**RE: City of Seguin  
Lawson St. Reconstruction  
Change Order #3**

**Contract Change Order No.3  
Lawson Street Reconstruction  
16" Water at Kingsbury at the Yukon Property**

**Re:** City of Seguin - Lawson St Reconstruction  
 CP#3 - 16" Water Main along Kingsbury

**PLAN AND PROFILE STA. 1+41 TO 4+30**  
**IH-10 AND FM 464 WATER LINE EXTENSION**  
**SEGUIN ECONOMIC DEVELOPMENT CORPORATION**  
**SEGUIN, TEXAS**

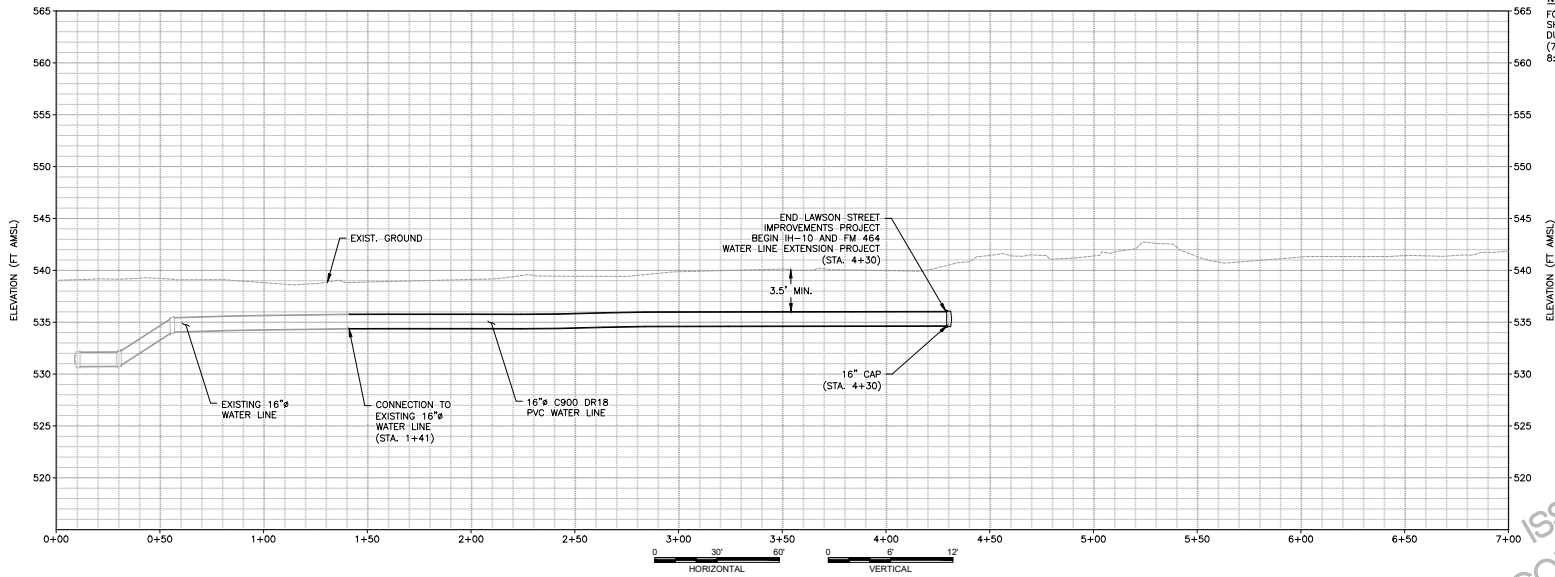
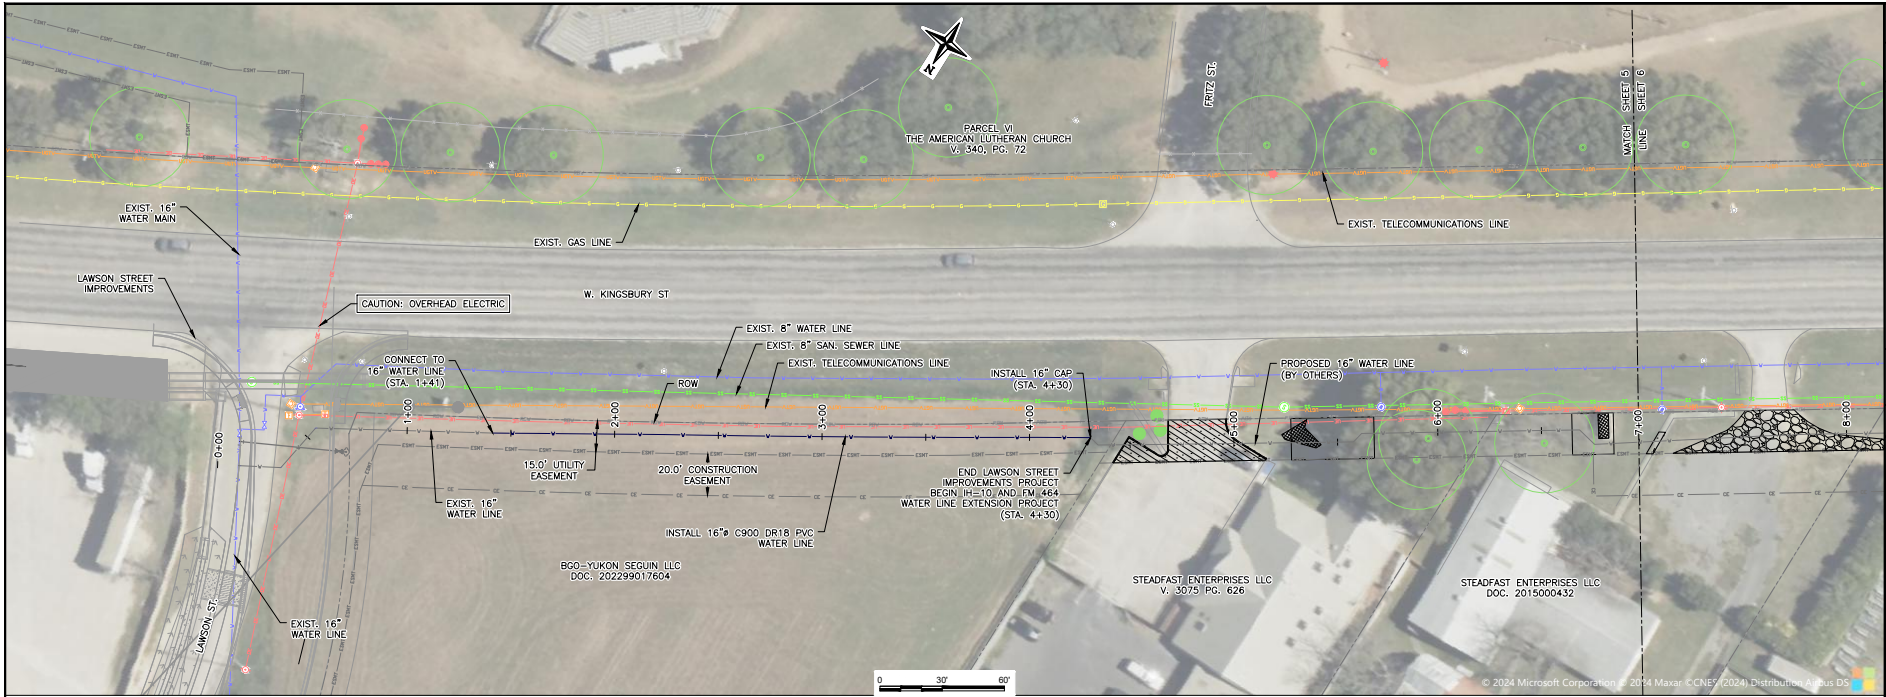
This change order includes installation of additional 16" water main along Kingsbury along the Yukon property as shown on page one of the Trihydro's plansheet.

- Contractor proposes to install additional 16" water main along Kingsbury as shown on page one of the Trihydro plansheet.
